9/5' VEERHAVEN.

NEW TWEENDECK IN N^o 1 HOLD

PROPOSED ALTERATION ON SECTION OF
HATCH - SIDE-CORINGS

Modification to Hatch
Coaming in twin deck
in No. 1 Hold

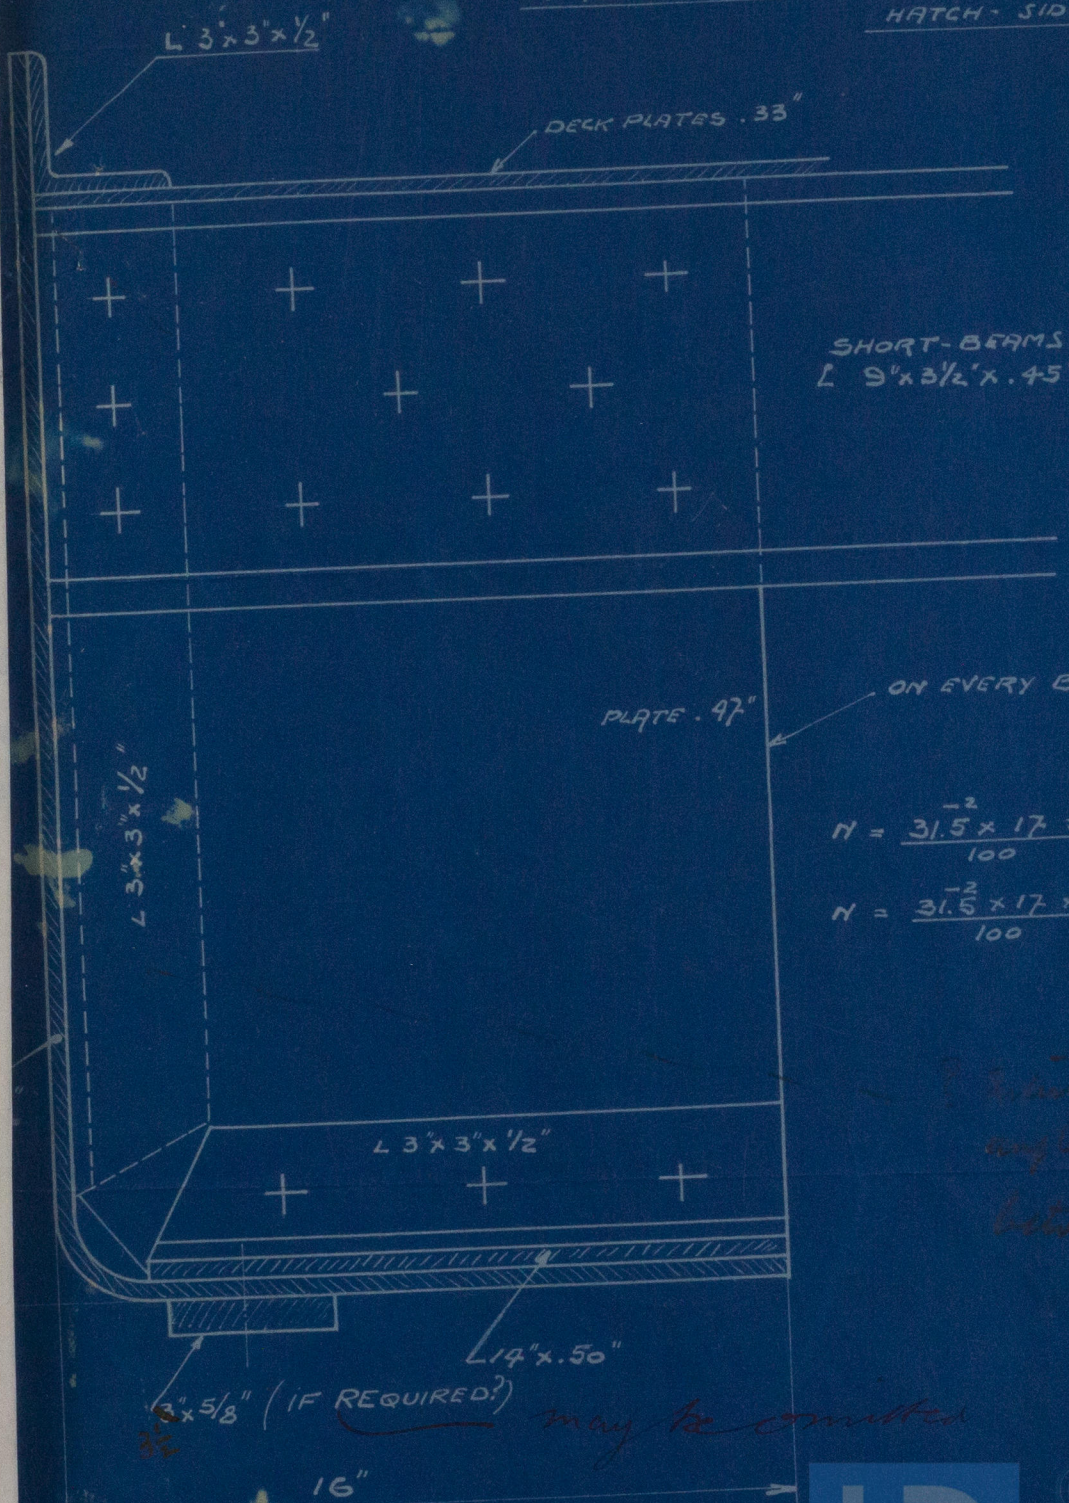
*Intermittent Rivets
angle to corning
between beams.*

NOTE TWEENDECK TO BE PLACED 8'-0" BELOW M^o DECK
AND NOT 9'-0" AS INDICATED ON APPROVED PLAN

$$N = \frac{31.5 \times 17 \times 8}{100} = 1350$$

$$N = \frac{31.5 \times 17 \times 9}{100} = 1520$$
